Agenda
for
139th PCC Meeting

EASTERN REGIONAL POWER COMMITTEE

AGENDA FOR 139th PROTECTION COORDINATION SUB-COMMITTEE MEETING TO BE HELD ON 26.09.2024 AT 10:30 HRS THROUGH MS TEAMS

पूर्वी क्षेत्र के 220/132 केवी काटापल्ली उप-केन्द्र में ग्रिड घटना पर विस्तृत रिपोर्ट / Detailed Report of grid event at 220/132 kV Katapalli S/s of Eastern Region
(To be submitted by RLDC/NLDC during Grid Disturbances/Grid Incidents/Near Miss Event as per IEGC section 37.2 (f))
(आई ई जी सी 37.2 (एफ) के अनुपालन में)

Fig 2: SCADA flow of 132 kV Purnea-Purnea T/c

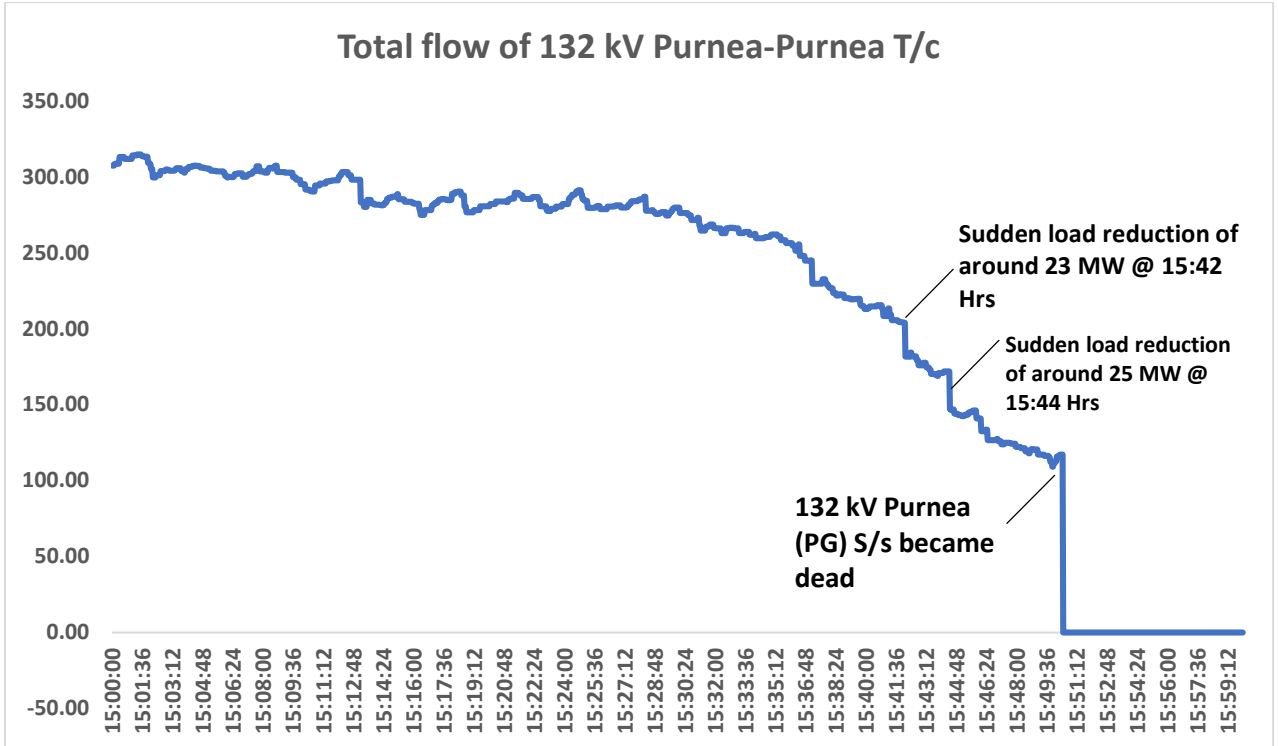
- There was multiple tripping in the downstream of 132 kV Purnea S/s of Bihar between 15:40 Hrs-15:50 Hrs.

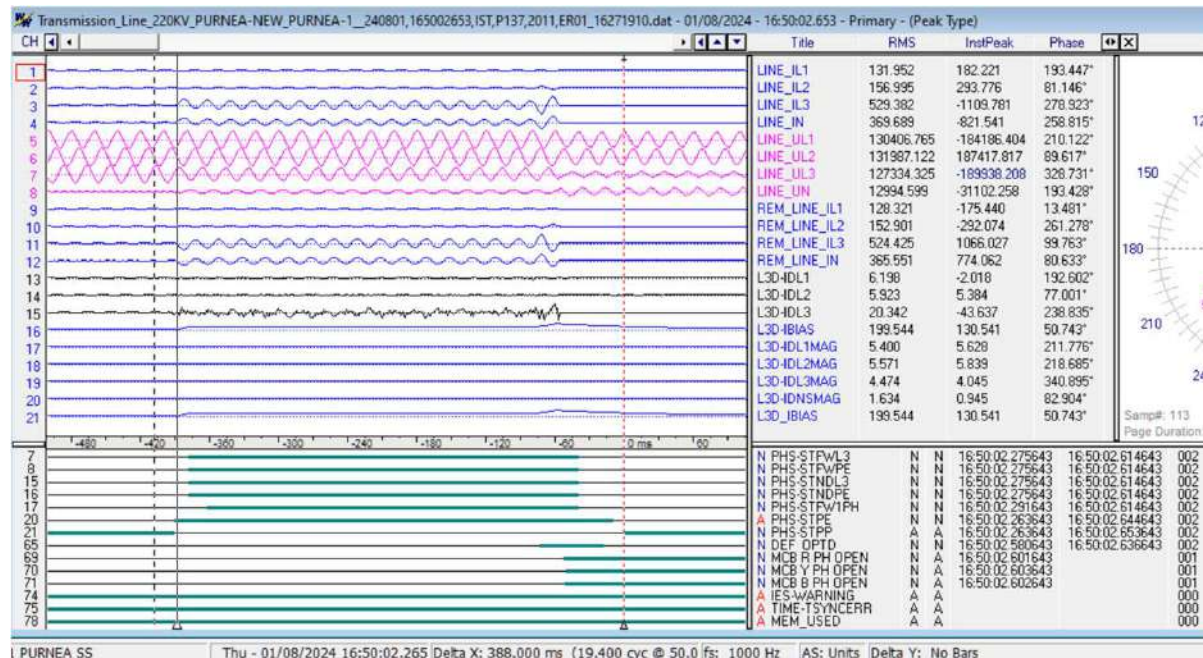
Fault Current: 0.79kA, Fault Distance- 5.3kM. Zone-3 Settings: 1.0 Sec and optd time: **1.01 Sec**

Also, it is observed that Backup O/C & E/F Protection got picked up.

As per DR Observation, Initially the fault was detected as 7.0kA and after the tripping of 220kV Purnea – New Purnea 1 & 2 Line after 0.3 Sec the fault current reduced to 2.6kA.

It is proposed that the settings of O/C and E/F Fault Protection in 132kV Purnea- Purnea (BSPTCL) feeders may be advanced and 220kV Purnea – New Purnea Feeders may be increased to provide the downstream level to clear the fault.
